RECEIPT DATE: 3-3-16 **ONSITE SEWAGE DISPOSAL SYSTEM** P 558020

PROPERTY ADDRESS: 15221 Sweetbay Street

SUBDIVISION: Belle Haven Estates LOT: 43 TAX ID: \_\_\_\_\_

**From:** Oswald, Hank  
**Sent:** Tuesday, December 08, 2015 1:41 PM  
**To:** 'Brian Collins'  
**Cc:** Willett, Chester  
**Subject:** RE: BAT Plan & FP Questions\_Belle Haven Estates\_Lot 43  
**Attachments:** Table 4.4.pdf

**TOTAL DYNAMIC HEAD CALCULATIONS**

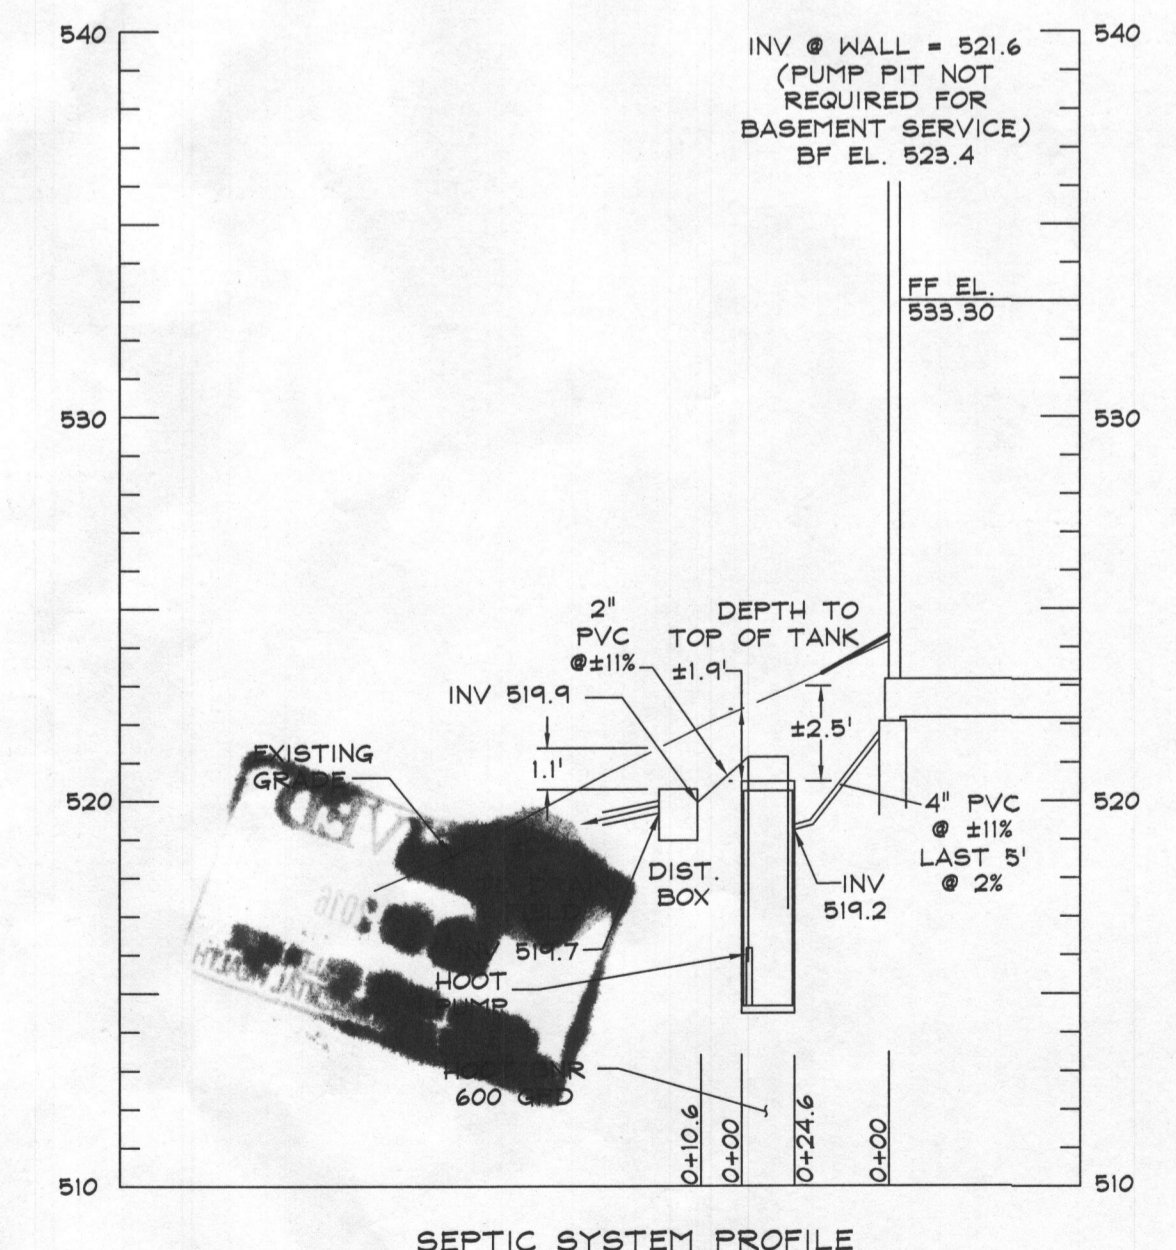
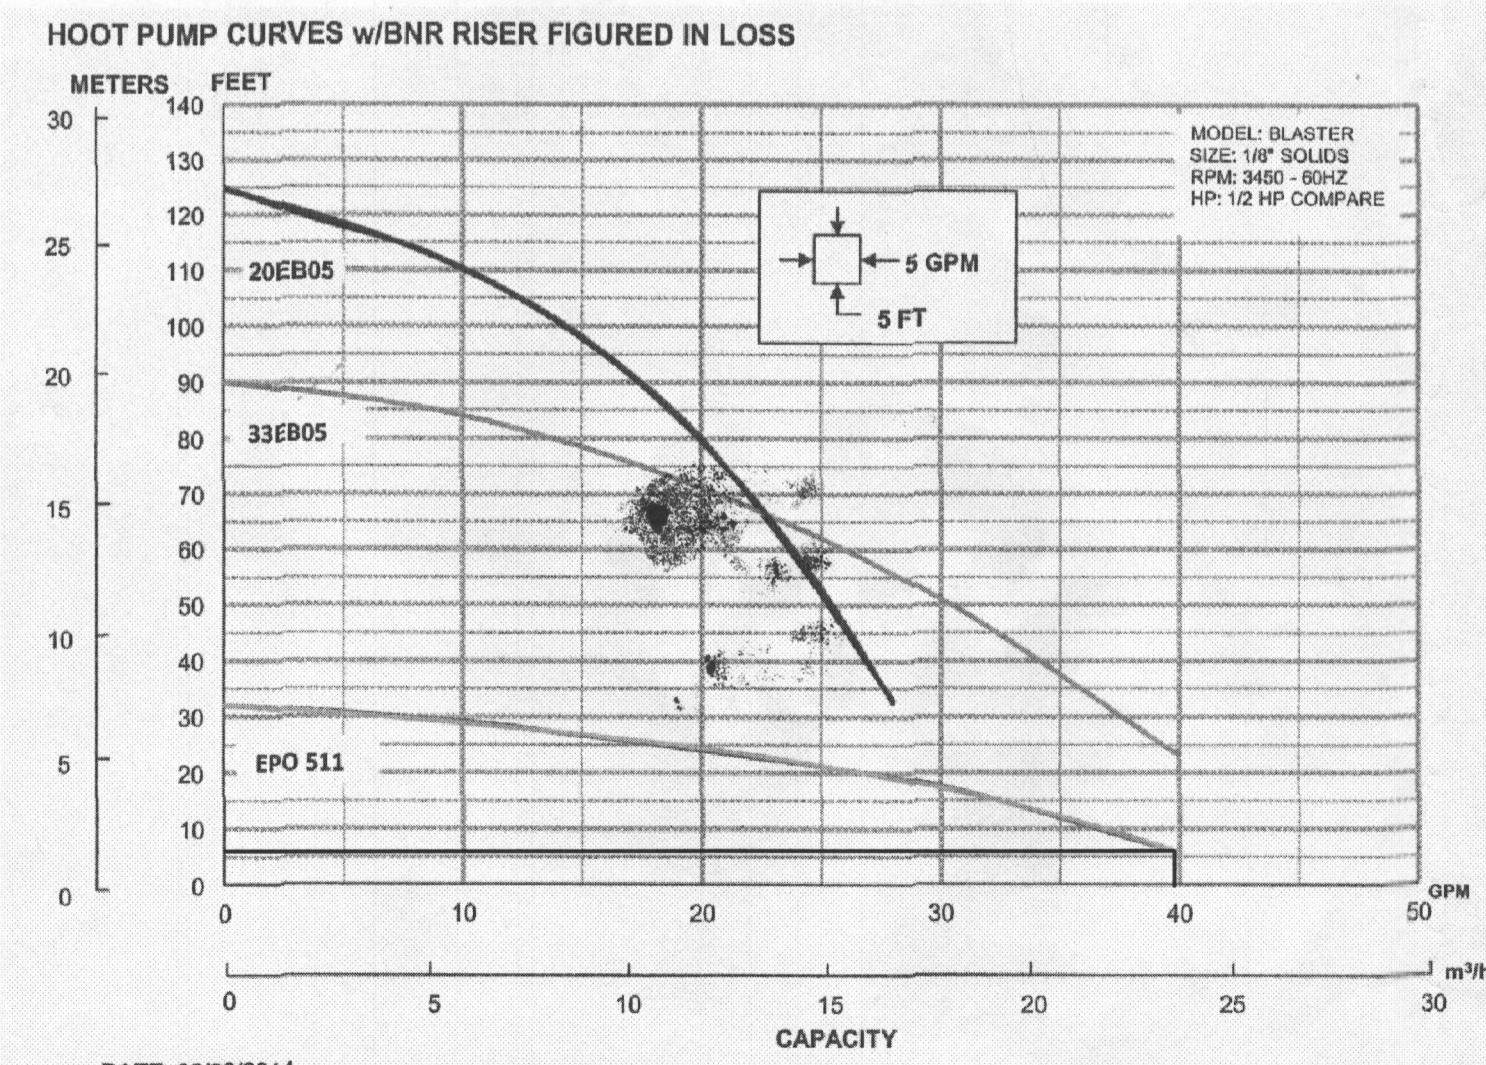
At 35 gpm, the velocity is too strong for a 1 ¼ (It's off the table). Please see attached Table 4.4. It would be better to increase to a 2 inch pipe and use friction loss factor of 2.05.

Under Friction Head, where did **13.62** come from?

In Response to your question below. The 13.62 is the Friction Loss Factor. To calculate the friction loss for odd lengths we multiply the total length of pipe divided by 100, by the friction loss factor. Which is basically a number we get off a chart for the friction loss over 100' of an 1"-1/4 pipe.

30.3/100 x 3.10 = 1.0' TOTAL FRICTION LOSS
